APPLICATION NO.	FILING DATE	FIRST NAMED INVENTOR	ATTORNEY DOCKET NO.	CONFIRMATION NO.
10/601,332	06/20/2003	Ubaldo Mastromatteo	2110-46-3	6985

Office Action Summary	Application No. 10/601,332	Applicant(s) MASTROMATTEO ET AL.	
	Examiner A. J. HEINZ	Art Unit 2653

Addendum A

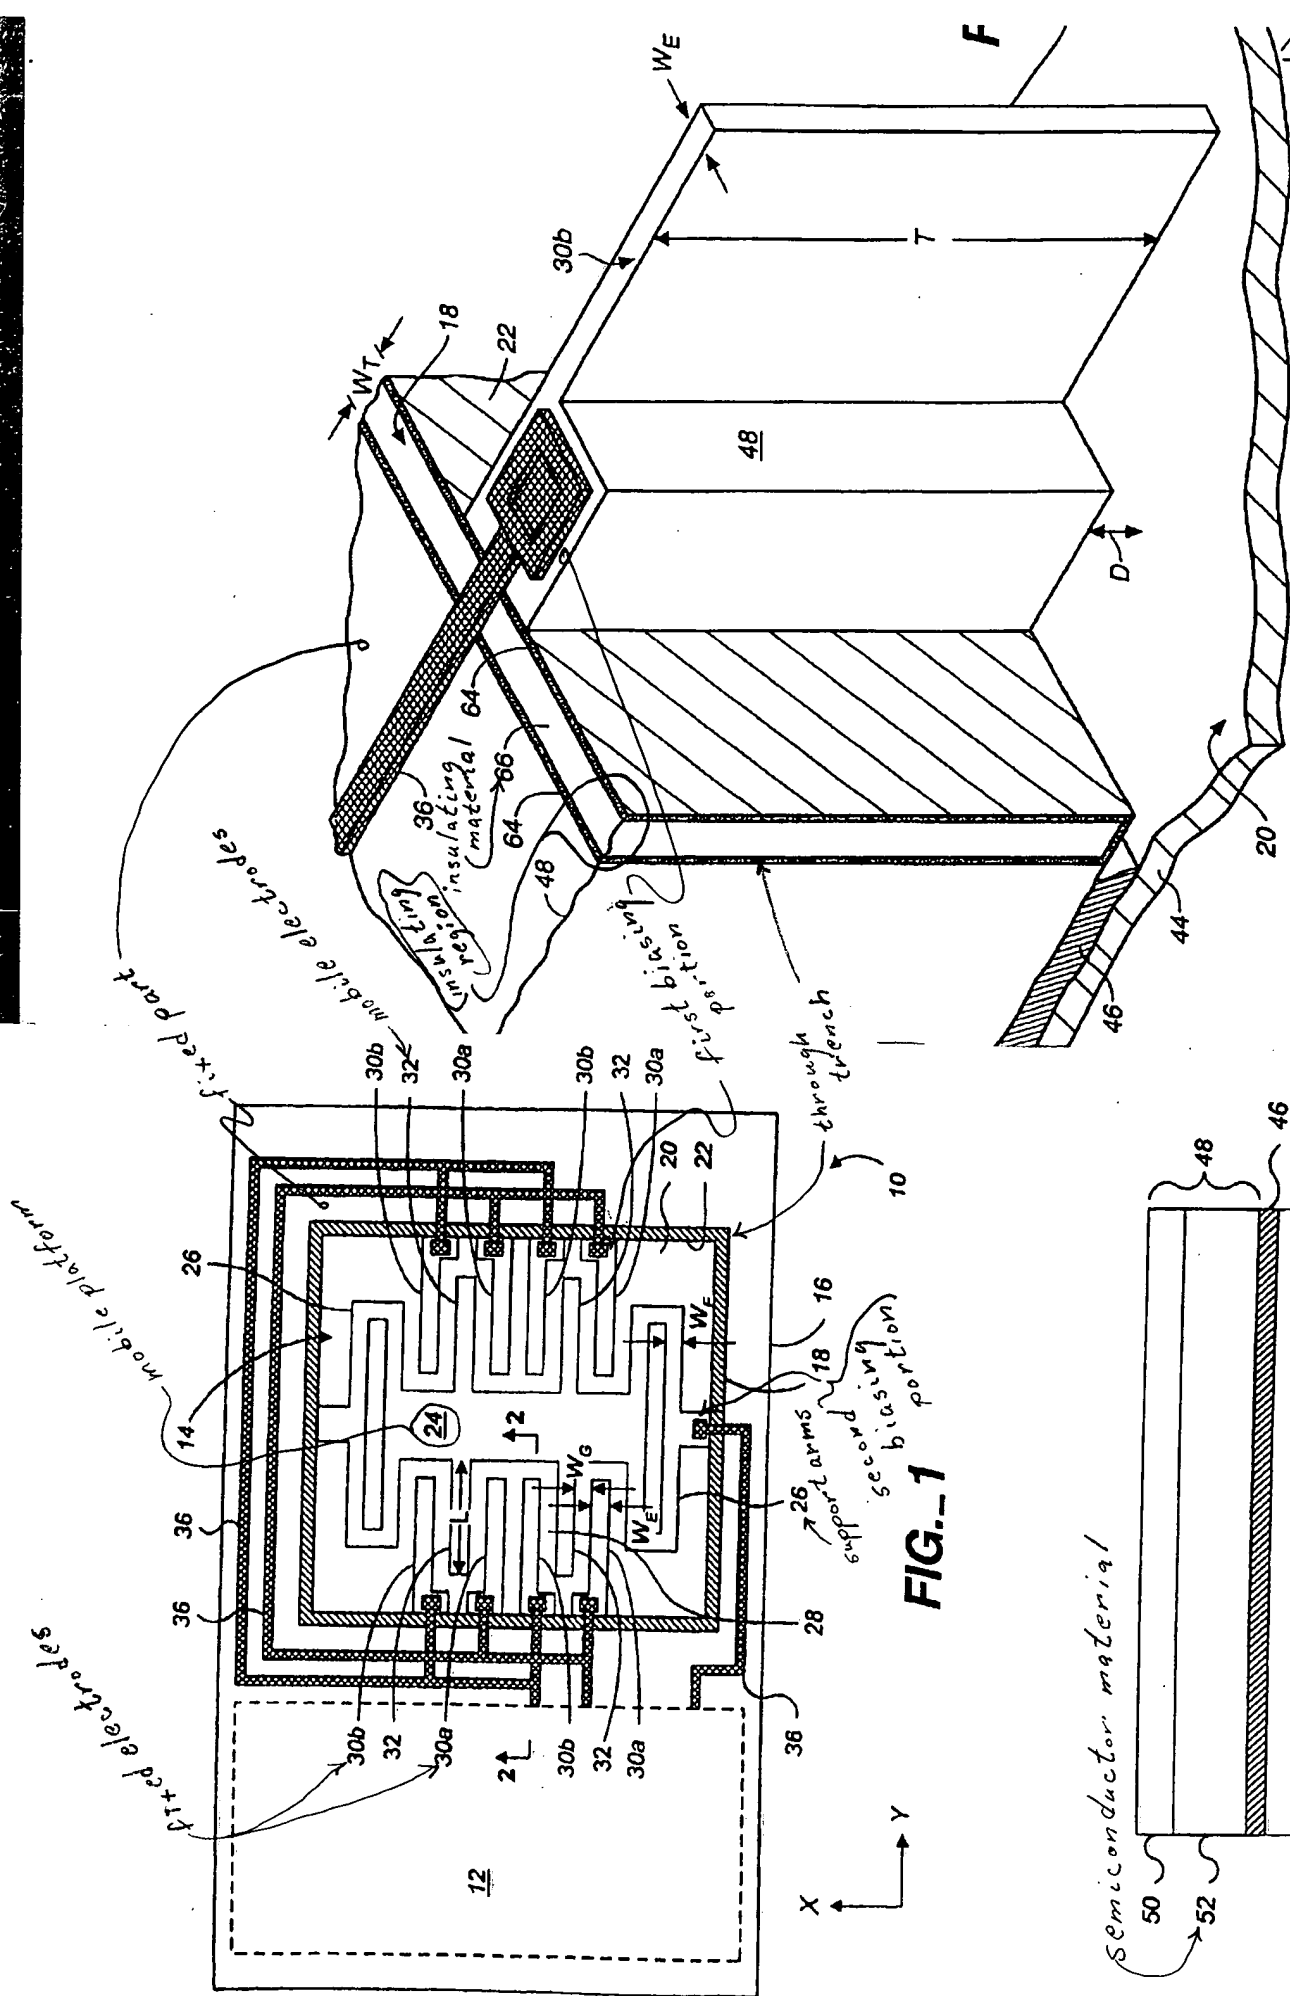
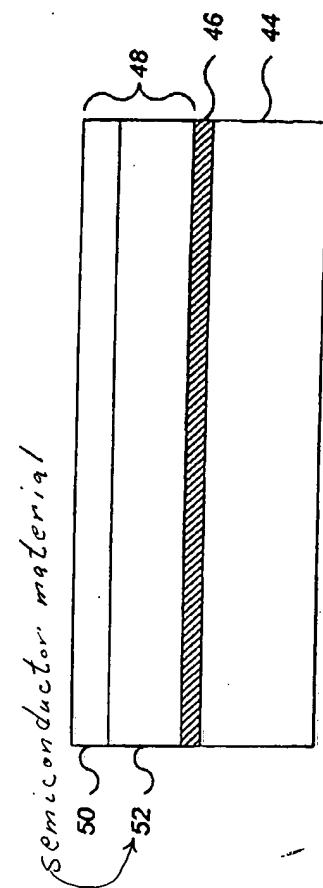
4. Claims 1-3,6,7,9,17-19 are rejected under 35 U.S.C. §102(b) as being anticipated by Brosnihan.

See Figures 1,3&4. Note, to the extent claimed and understood, the structure as shown in Addendum A reads on and performs to the same degree as claimed.
